STATE OF NORTH CAROLINA
DEPARTMENT OF TRANSPORTATION

May 1, 2020

Subject: Revised Modification Request for the Section 404 Individual Permit and Section 401 Water Quality Certification for the proposed Havelock Bypass in Craven County. TIP No. R-1015. Debit \$ 570 from WBS 34360.1.2

PERMIT DRAWING
SHEET 102 OF 167

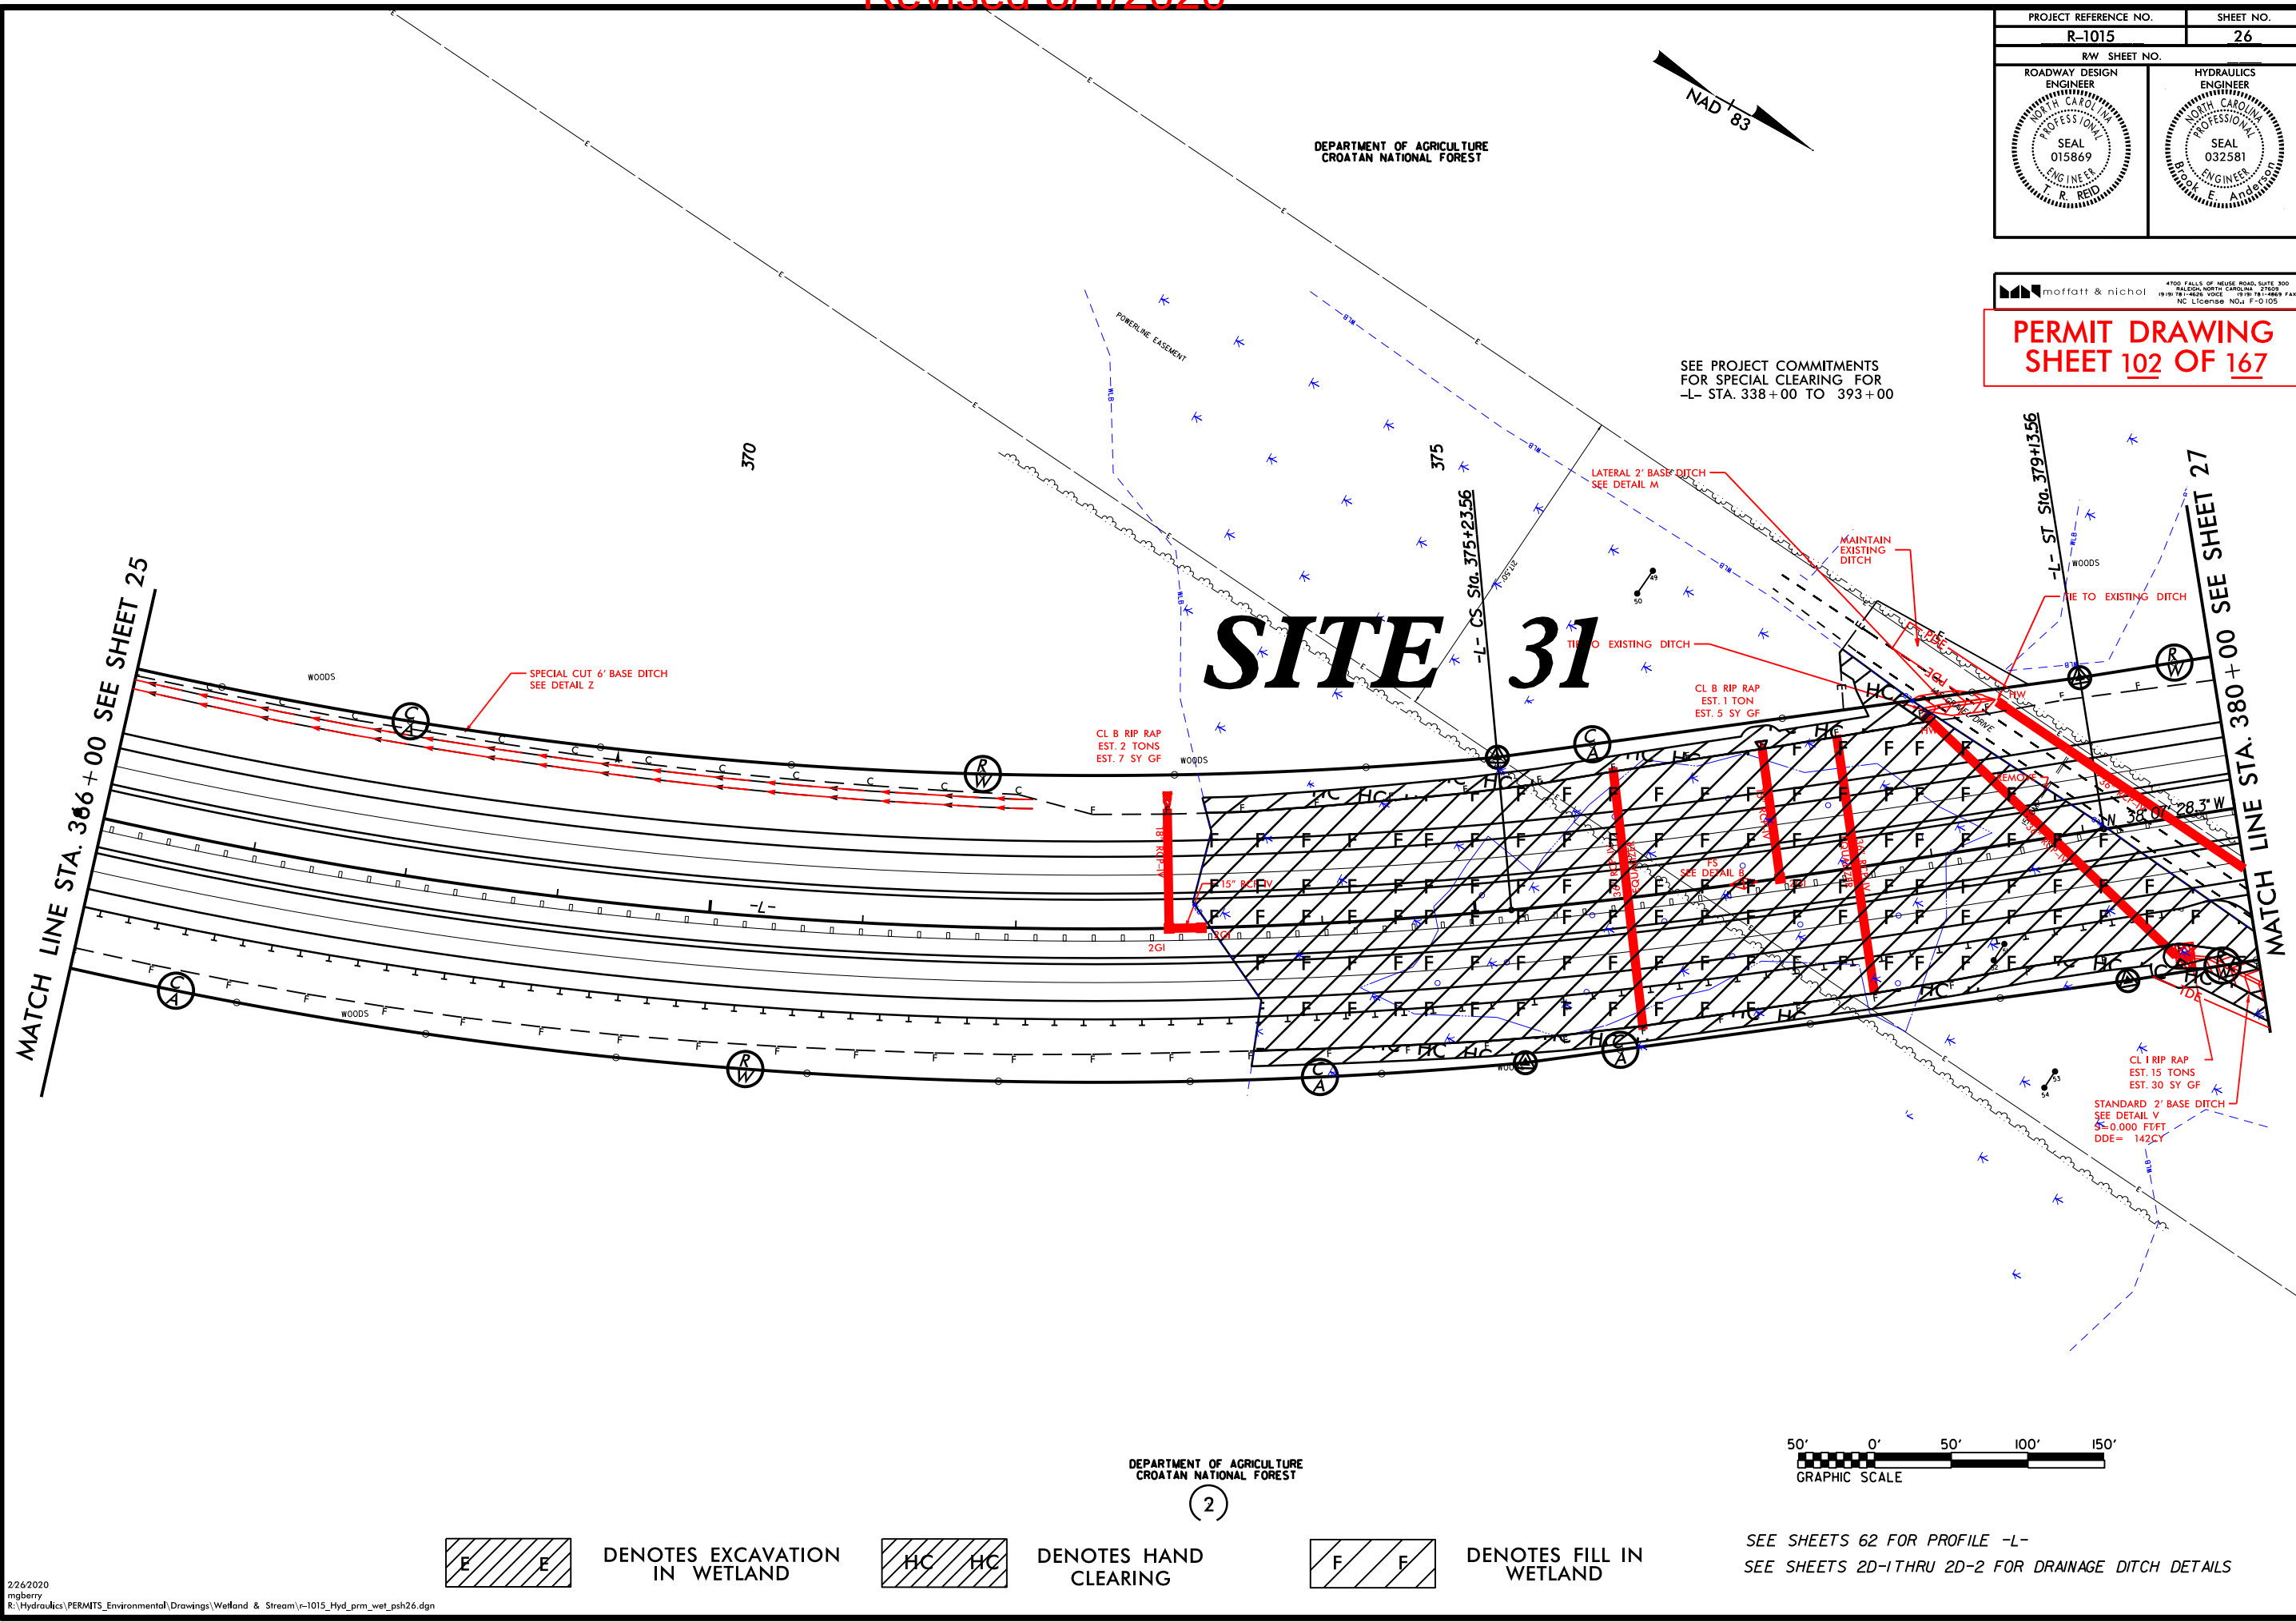
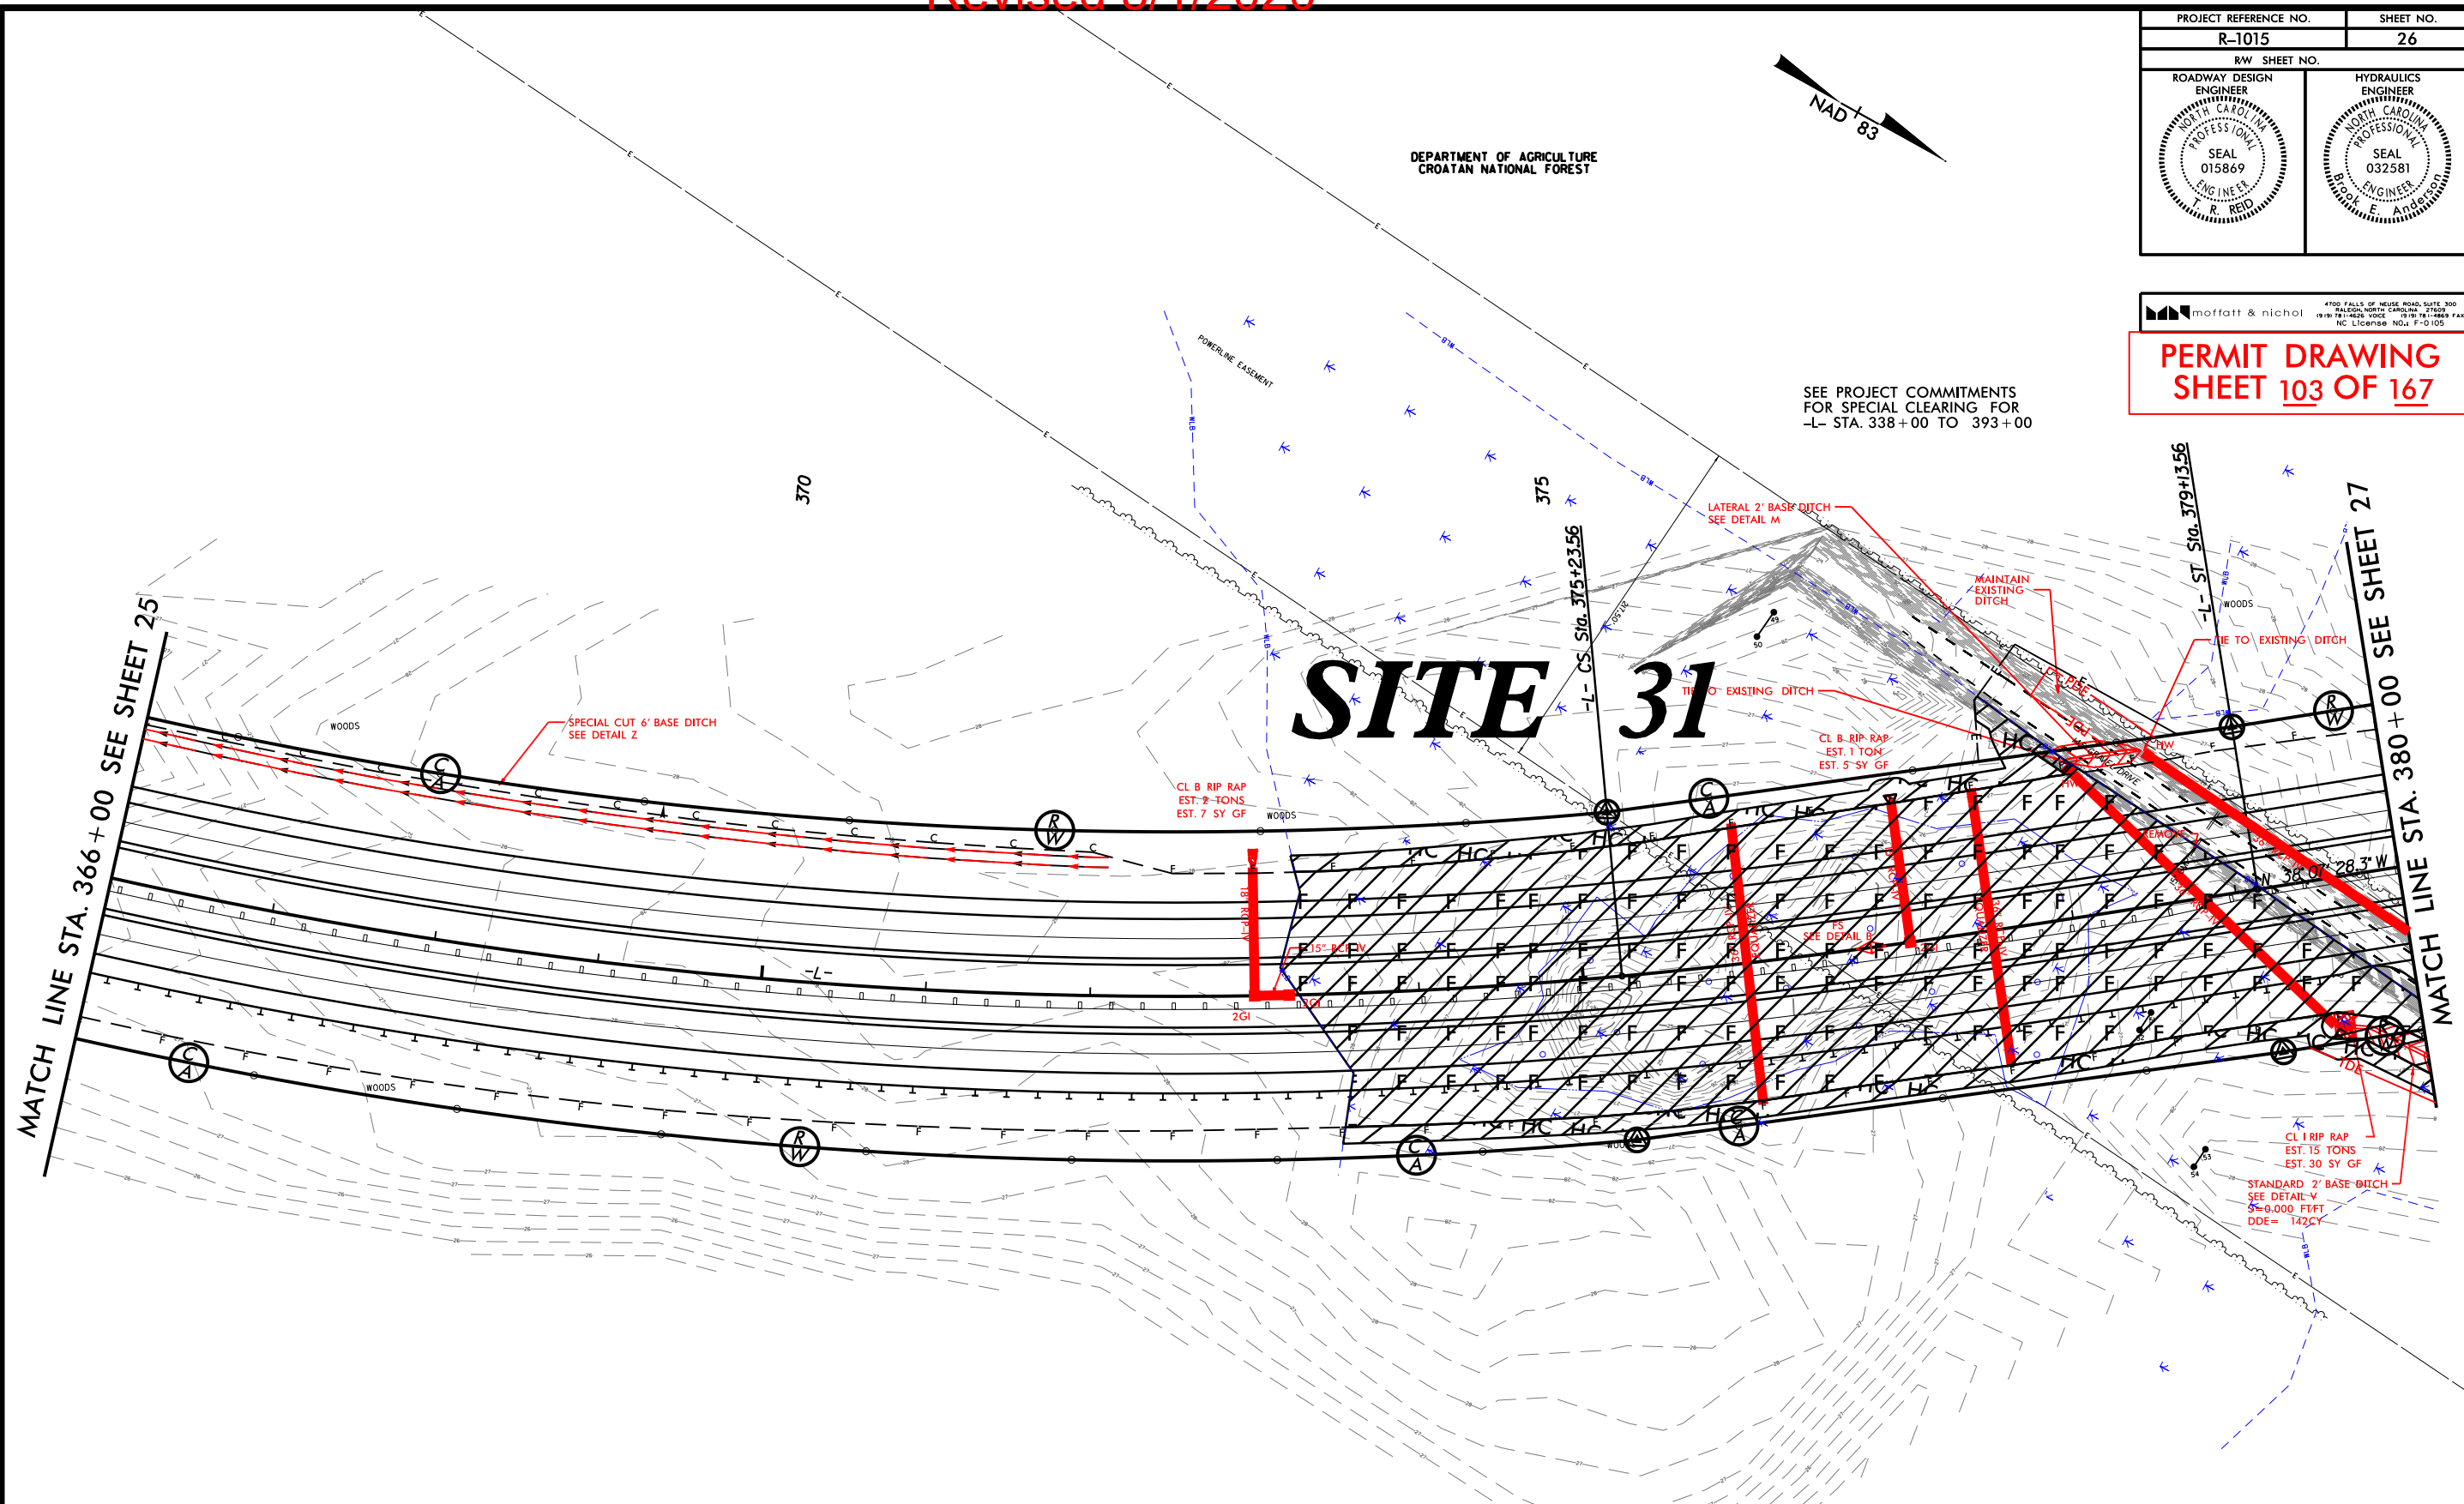
- Actual Excavation in Wetlands increase by 0.0265 acre (new = 0.079 acre, old = 0.053 acre)
- Site 31: omitted in 3/12/20 modification request (permit sheets 102 & 103). Access drive was removed. Fill in wetlands reduced by 0.01 acre. Excavation in Wetlands reduced, but the reported amount did not change.

- Fill in Wetlands (new = 2.2231 acre, old 2.2289 acre)
 - Excavation in Wetlands (new = 0.068 acre, old 0.072 acre)
- Site 47, (permit sheets 142 & 143) pipe shortened to eliminate easement on property, HW added. “Temporary Impacts in Surface Water” reduced by 0.01 ac. “Existing Channel Impacts Temp.” reduced by 10’.

PERMIT DRAWING
SHEET 124 OF 167

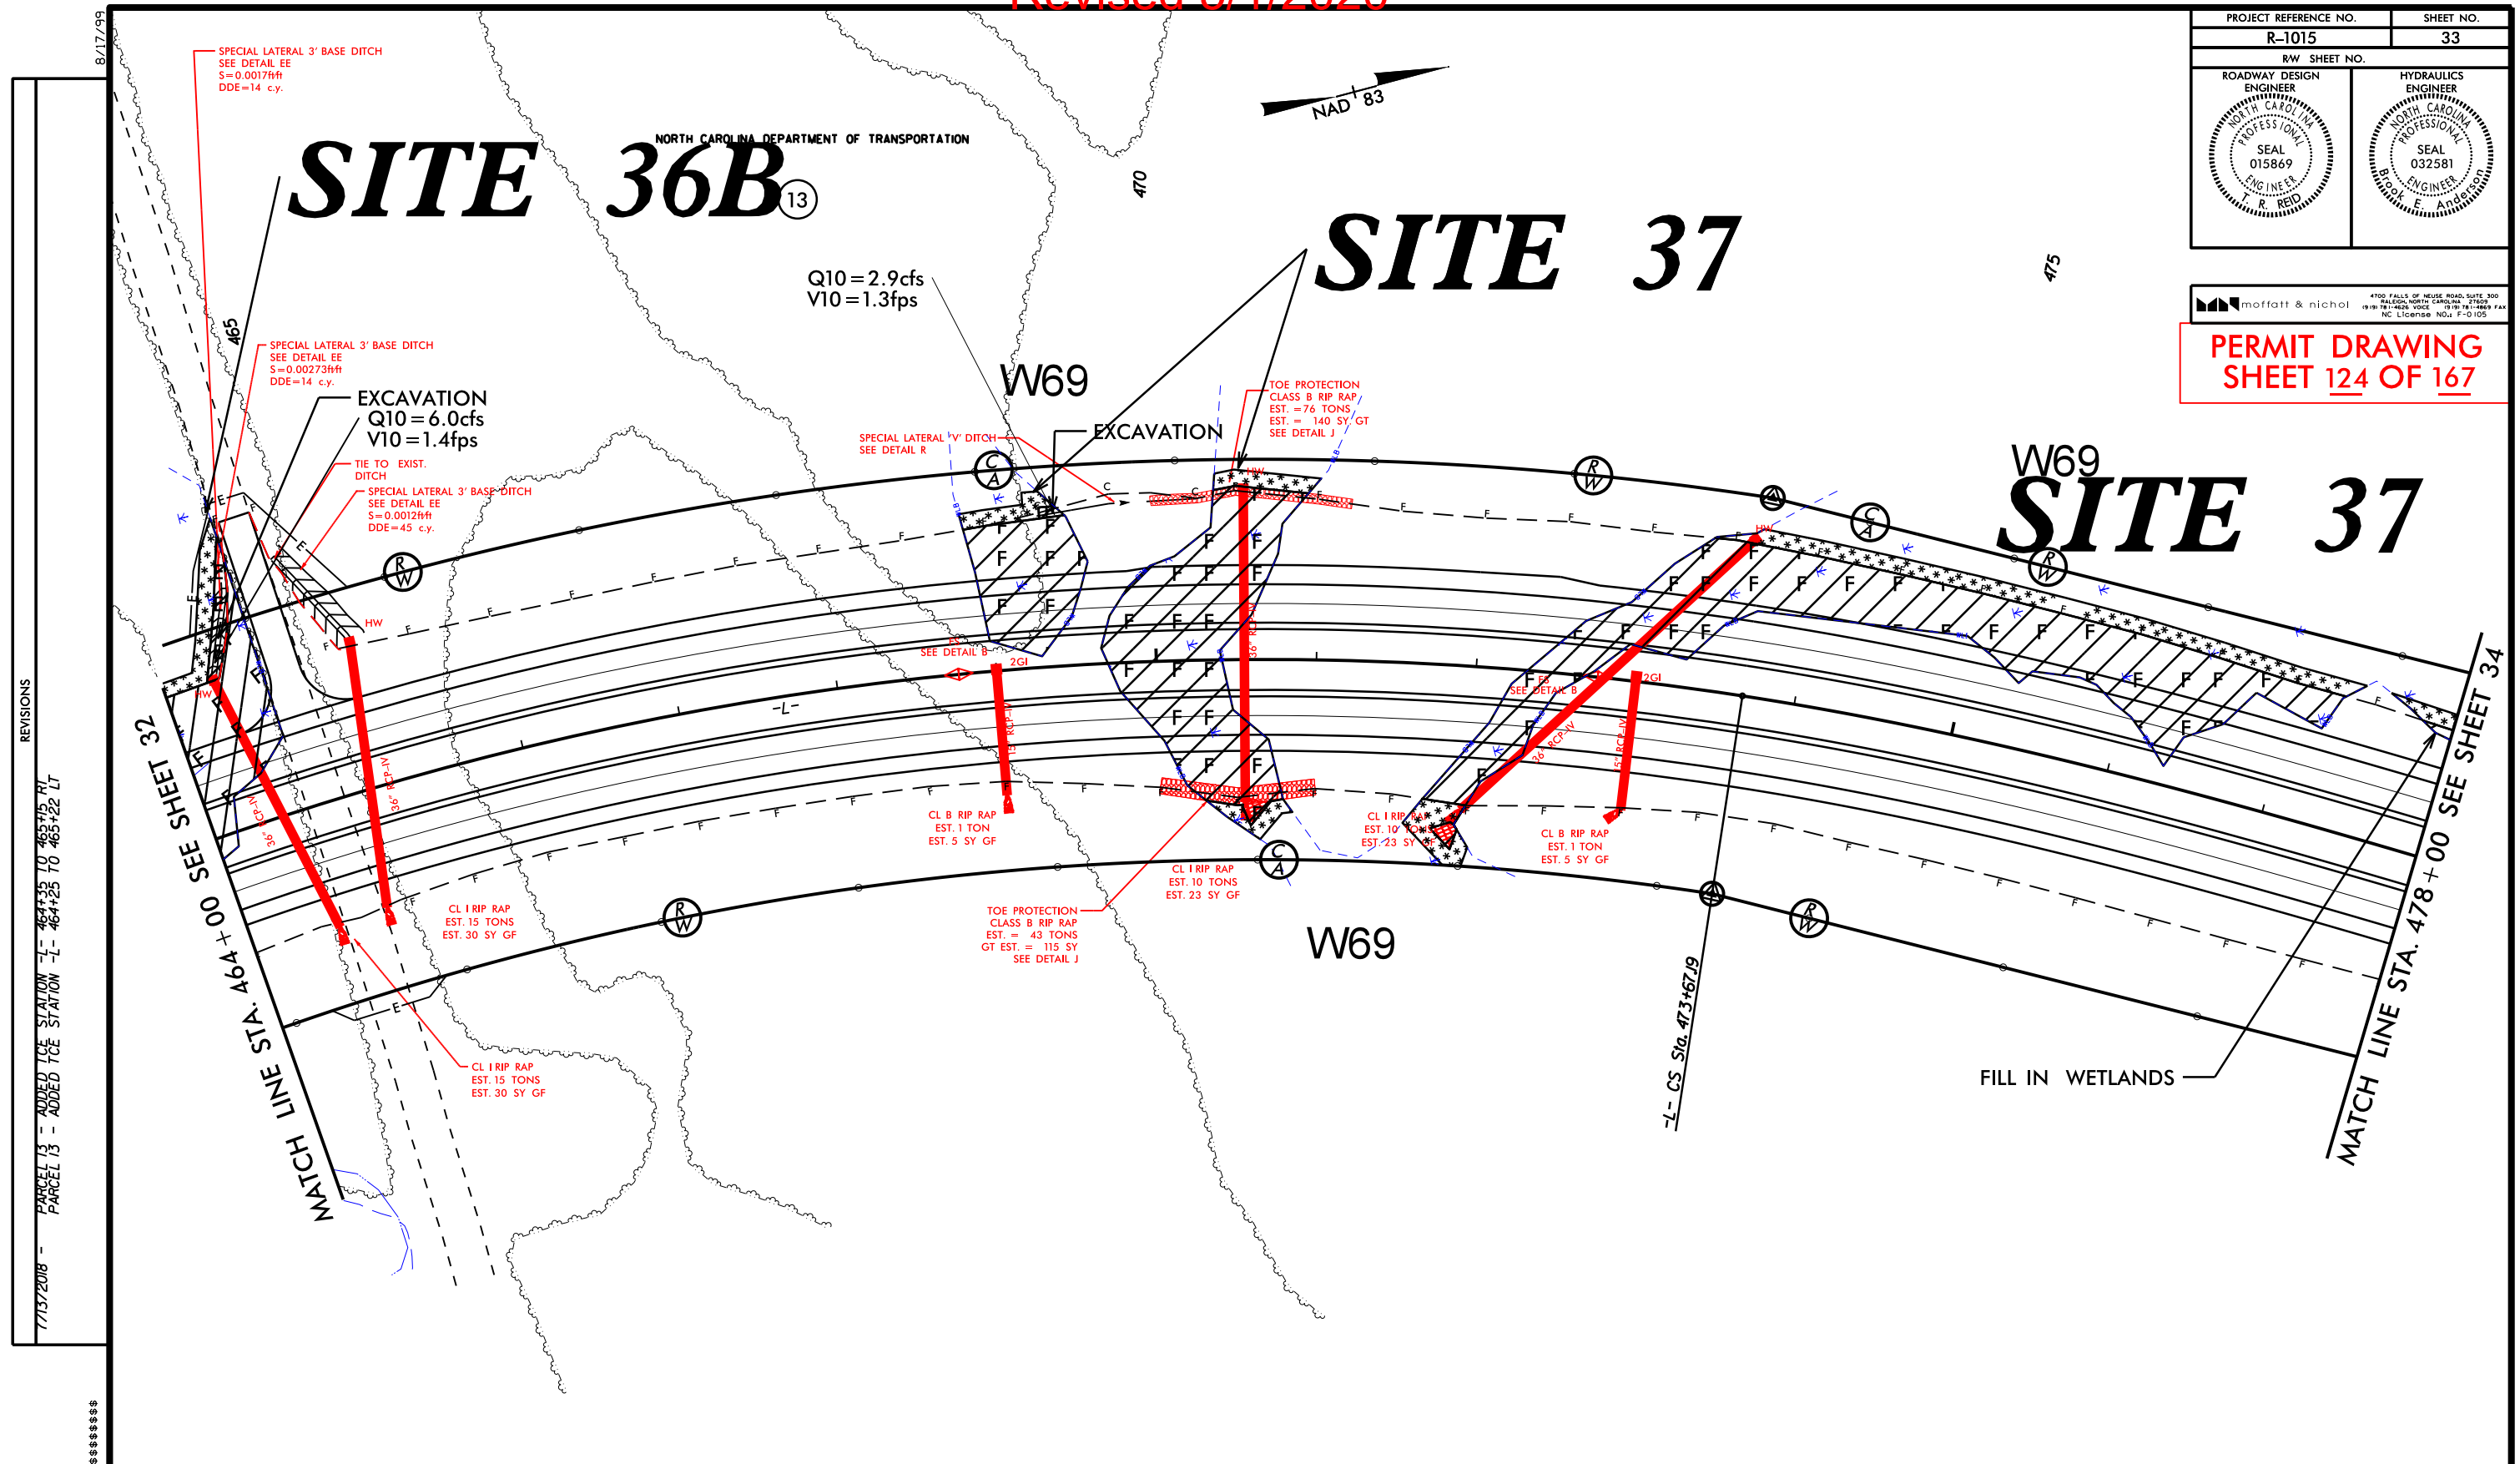
- Update to permit sheets 124 & 125. Changes were outside of impacted areas
- Update to permit sheets 130 & 131. Changes were outside of impacted areas
